**PRODUCT / PROCESS CHANGE NOTIFICATION**

<b>1.1 Company</b>		STMicroelectronics International N.V
<b>1.2 PCN No.</b>	ADG/18/10788	
<b>1.3 Title of PCN</b>	PCN - Capacity Extension for STH260N6F6 to HHGrace	
<b>1.4 Product Category</b>	Power MOSFET	
<b>1.5 Issue date</b>	2018-03-26

**STH260N6F6-2 Capacity Extension in HHGrace Foundry**

**BVDSS @ 1mA  
(Spec. > 60V)**

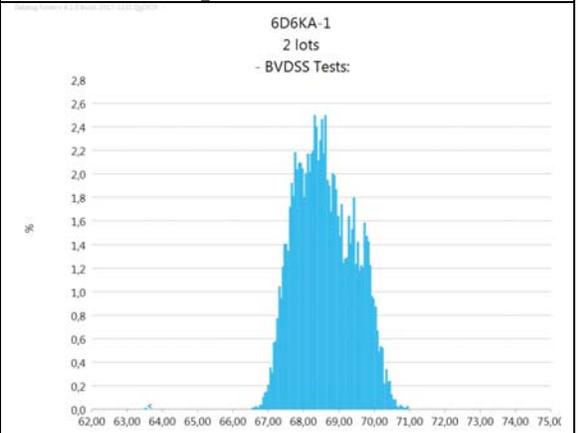
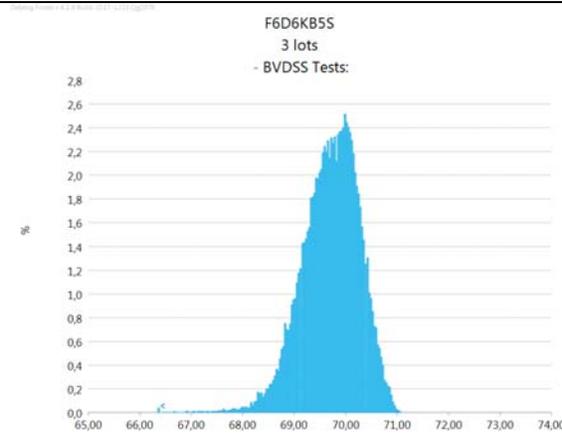
The Electrical Characterization, at wafer level, performed on 3 different lots has demonstrated all the electrical parameters are aligned with current production.
